LEE'S SUMMIT
MISSOURI
Development Services Department

Development Services Staff Report

File Number	PL2022-168
File Name	SIGN APPLICATION – Legacy Park
Applicant	City of Lee's Summit
Property Address	901 NE Bluestem Dr 1201 NE Legacy Park Dr 1501 NE Legacy Park Dr
Planning Commission Date	May 12, 2022
Heard by	Planning Commission
Analyst	Hector Soto, Jr., AICP, Senior Planner

Figure 4 - Typical specification of proposed ground signs

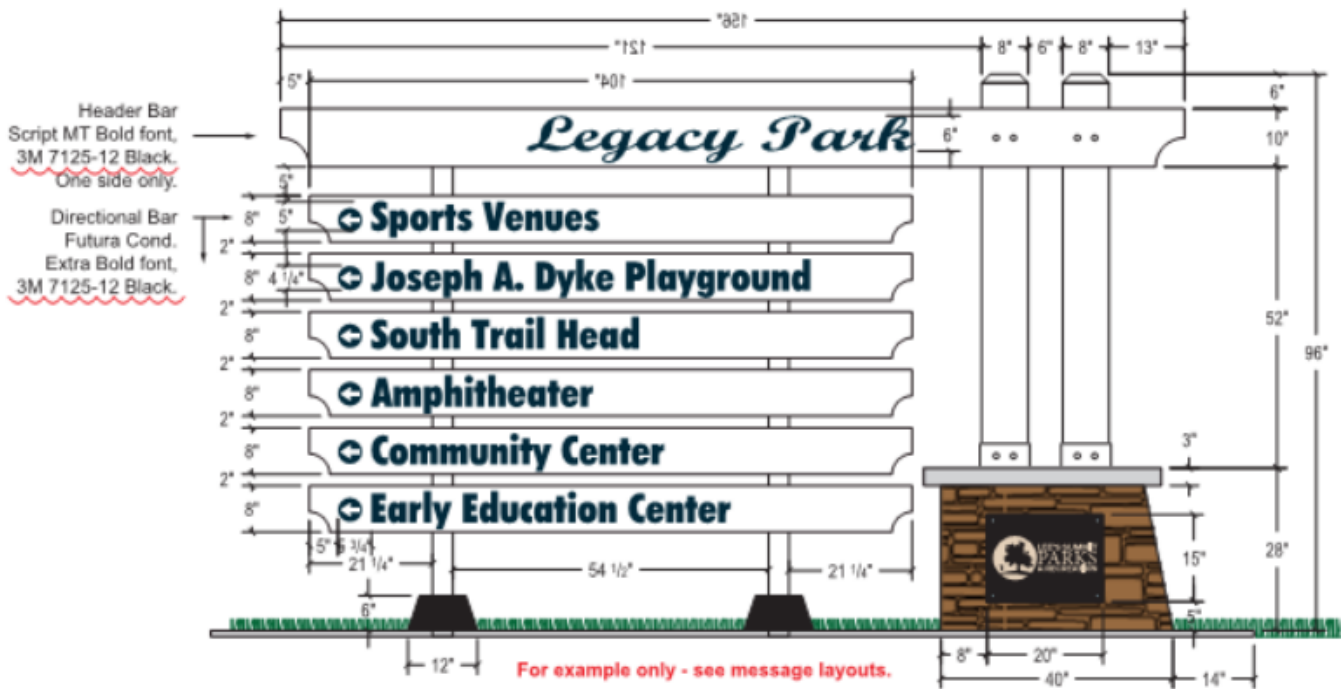
The proposed signs will supplement the existing signs by providing two wayfinding signs at each intersection. NE Blackwell Pkwy is an arterial roadway divided by a landscaped median of varying width. The separation between the northbound and southbound lanes along NE Blackwell Pkwy at the three park entrances are 60' (north entrance) and 180' (middle and south entrances). The two new signs at each intersection will be located on opposite sides of the intersection diagonal from one another—each intended to provide direction for northbound and southbound NE Blackwell Pkwy traffic. The signs are taller, larger and greater in number than the freestanding sign standards allow by right for AG-zoned property.

Given the expansive 692-acre site, the number of facilities housed within the park, and need for improved wayfinding along NE Blackwell Pkwy, staff believes the proposed signs maintain a compatibility and proportionality that is appropriate for the site. With the conditions of approval below, the application meets the requirements of the UDO and Design and Construction Manual (DCM).

1. A total of three (3) freestanding signs (existing + new) shall be allowed at each of the three park entrances along NE Blackwell Pkwy as shown on the sign location map. The new ground signs shall not exceed the following size standards: 8' height; 57 sq. ft. sign face area; and 104 sq. ft. sign structure area.

2. In accordance with the City's Design & Construction Manual (DCM), the new ground signs shall maintain a minimum 15' of separation from any City public infrastructure (water, storm and sanitary sewer main), measured to the closest pipe edge of said infrastructure.

3. In accordance with the City's Encroachment Policy, the new ground signs shall be located outside of any City easements. If this is not possible, a license agreement shall be executed.
